Residential Development at
Little Pakyns, Albourne Road, Hurstpierpoint.

DESIGN & ACCESS & HERITAGE STATEMENT

LISTED BUILDING PLANNING APPLICATION

PART-RETROSPECTIVE APPLICATION FOR ALTERATIONS TO APPROVAL REF DM/23/2031

As currently built South Elevation
N.B. project still under construction, yet to be completed.

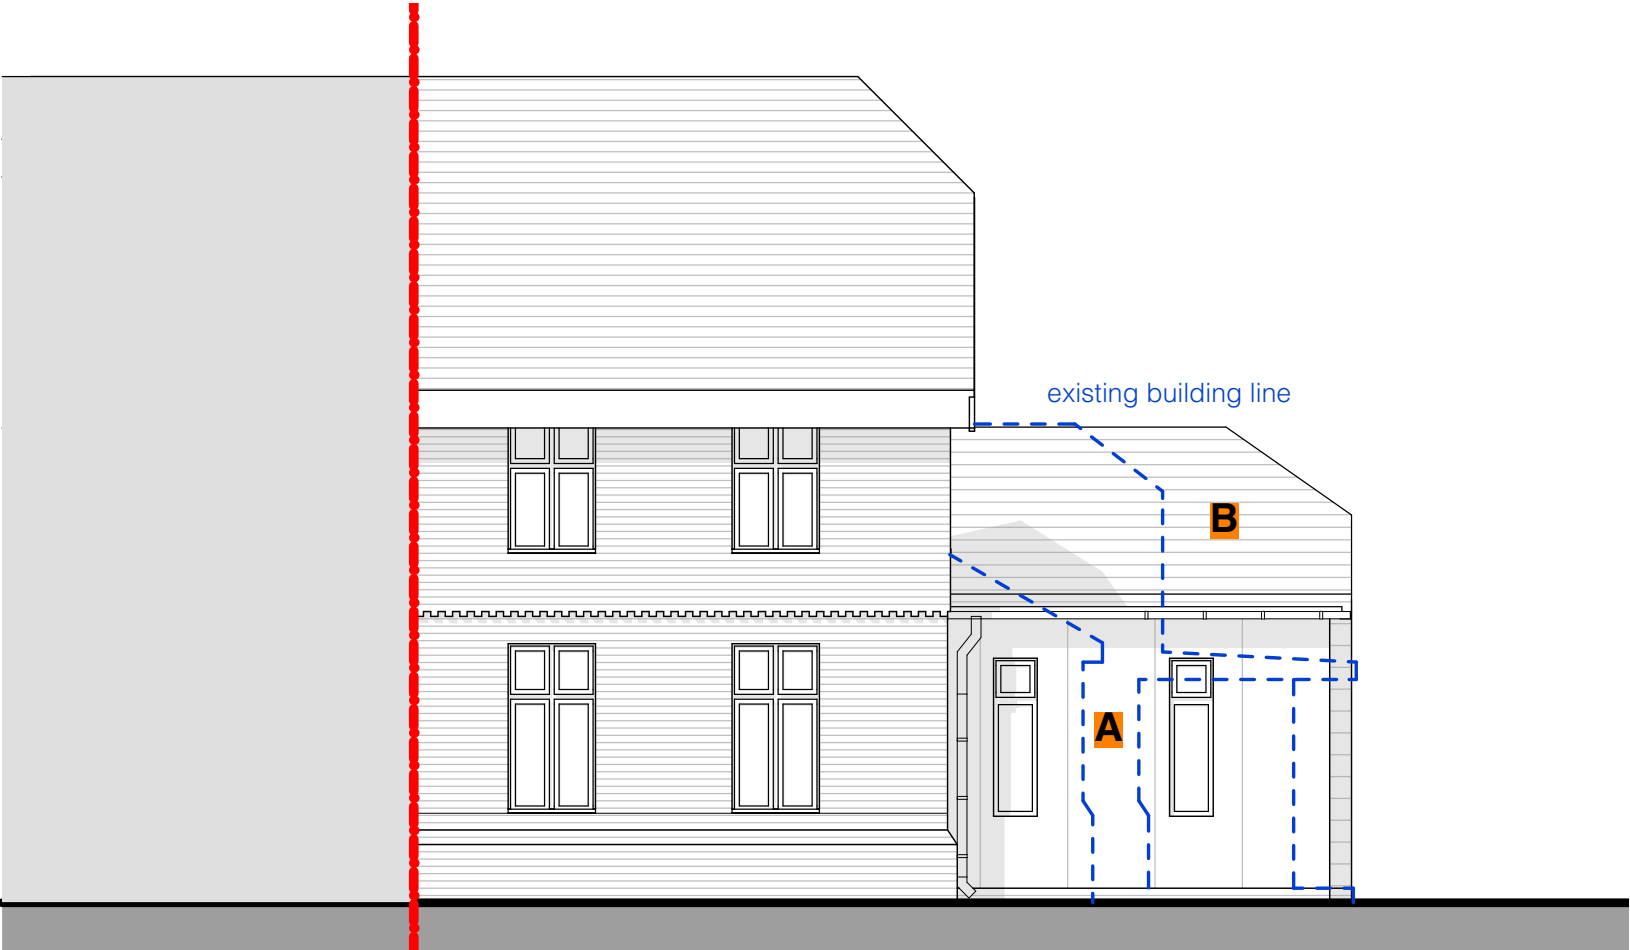
Comment from Emily Wade:

“As we noted on site the windows to the side elevation of the flat roofed element of the extension are not in accordance with the approved design. As we discussed during our site meeting, unfortunately the windows as installed are not sympathetic to the context. During a recent telephone conversation the property owner indicated that they would be willing to simply block up the window openings, however as this would result in an unrelieved, blank elevation I do not consider that this is an appropriate solution to the problem. In my opinion, the best option will be to alter the openings to match the approved design.”

The windows to the southern elevation are proposed to be amended to reflect those on the adjoining property's southern elevation.

This proposal was sent to Emily Wade via email for informal comment prior to submission of this application and she confirmed “...in my opinion the revised window design shown is likely to be acceptable” (email reply dated 21st July 2025).

Proposed external materials
N.B. project still under construction, yet to be completed.

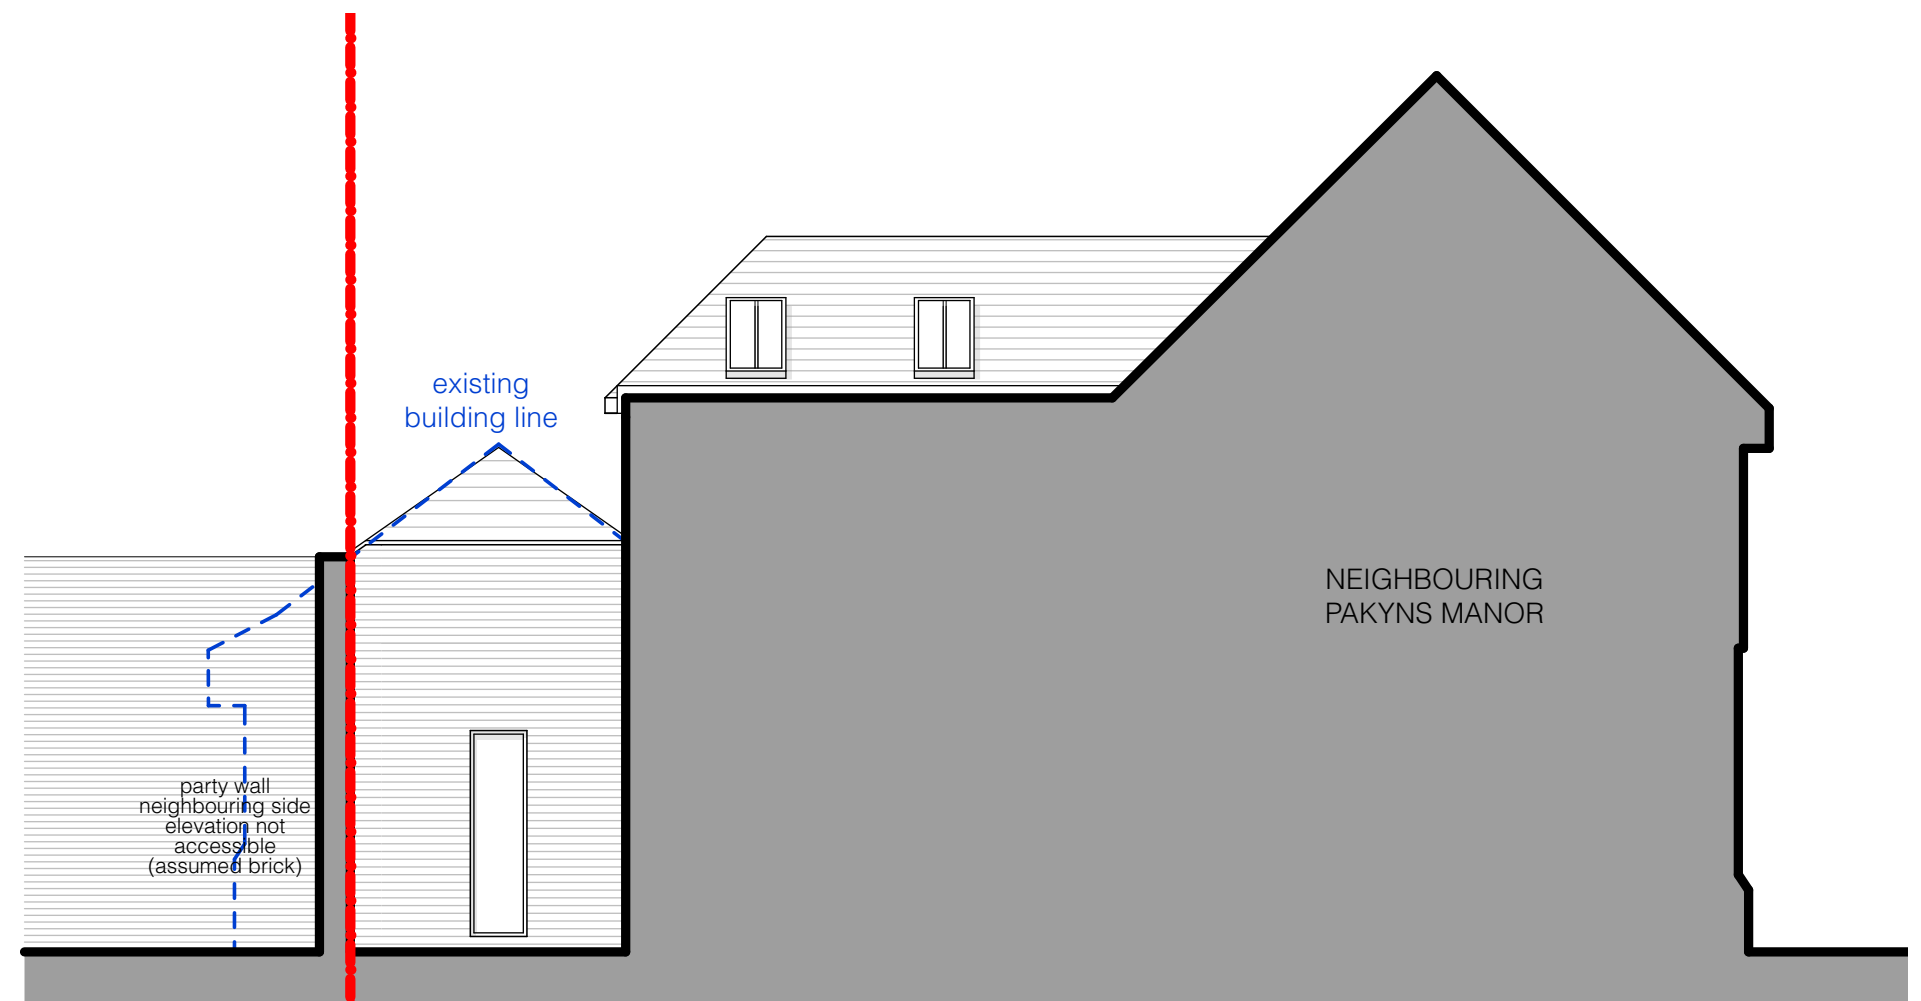
Comment from Emily Wade:

“The applicant has indicated to me that they intend to go ahead with the approved facing material to the flat roofed element of the extension, which is of course acceptable. With respect to the tiling to the gabled element, which is unacceptable as installed, it is my understanding that the applicant is still in discussions with the supplier to resolve the situation. We would expect the finished scheme to closely reflect the clean, contemporary lines shown on the approved drawings, including the profile of both the hung and roof tiles, and the ridge detailing. I would expect the applicant to provide further details of how this is to be resolved in due course.”

The proposed facing materials are to be as approved under the Approval of Conditions application. The building is yet to be completed therefore these have not been completed yet.

A Timber Cladding: Parklex Prodema Naturclad-W (Hazel Matte)

B Clay Tiles: Plasma (M25 brown)
